ISO/IEC 14443-2

Second edition
2010-09-01
AMENDMENT 1
2011-10-15

Part 2:
Radio frequency power and signal interface

AMENDMENT 1: Limits of electromagnetic disturbance levels parasitically generated by the PICC

Figure 18 — Illustration of allowed EMD spikes

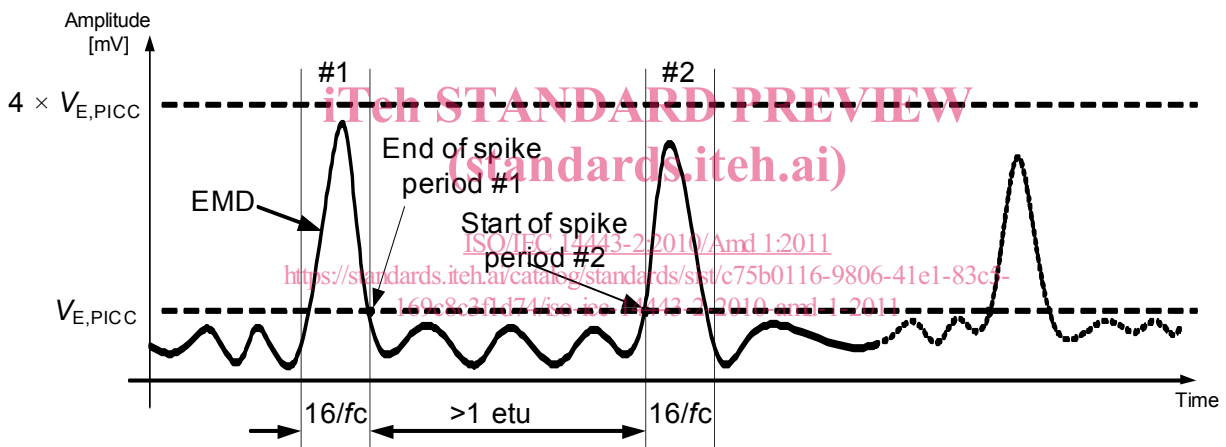
During this low EMD time, the EMD level may exceed $V_{E,PICC}$ for no more than two short periods of 16/fc if:

— it never exceeds $4 \times V_{E,PICC}$ and

— in case of two periods, the time between the two periods is greater than 1 etu.

Figure 18 shows an illustration of such allowed EMD spikes.
